MFD NON-COMPLIANCE REPORT # 31070-6

PART NAME: **MOUNTING PLATE**
PF/SA NO.: **PF-391-851-66 R0**
WORK ORDER NO.: **874113**
VENDOR **OSV**

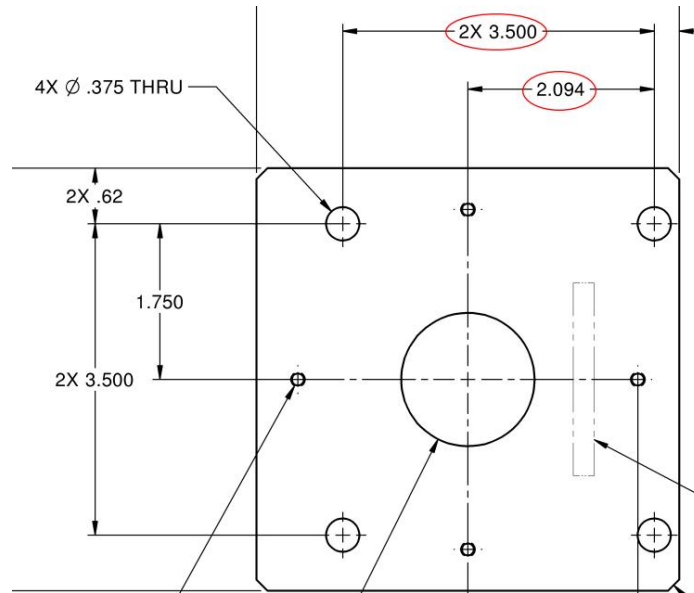
1. $2X\ 3.500 \pm 0.005$ measures 3.510 (+0.005" out of tolerance)
2. 2.094 ± 0.005 measures 2.104 (+0.005" out of tolerance)
